ADDENDUM NO. 2

PROJECT: WPCP Modifications (2021 CWSRF)
C&S Project No.: M9600.066

OWNER: City of Moultrie

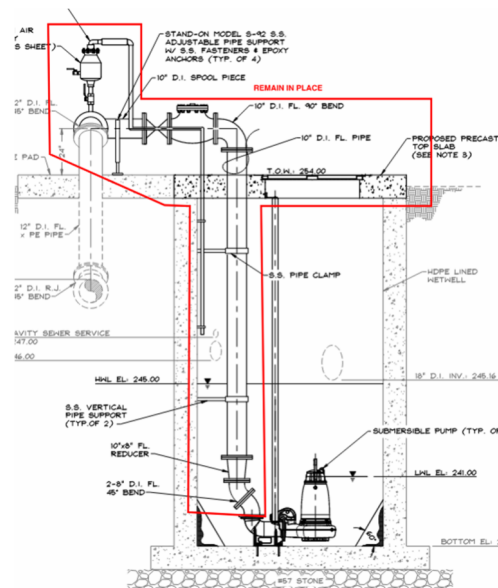
- A. DRAWING SHEET NO. 13 – FACILITY PUMP STATION MODIFICATIONS
PLAN & SECTION: Per the marked snippet below, the existing valves, piping, wetwell top, and hatch shall remain in place; **only the submersible pumps (w/ associated electrical components), guide rails, and base elbows shall be replaced.** Contractor shall also replace grouted floor as shown.
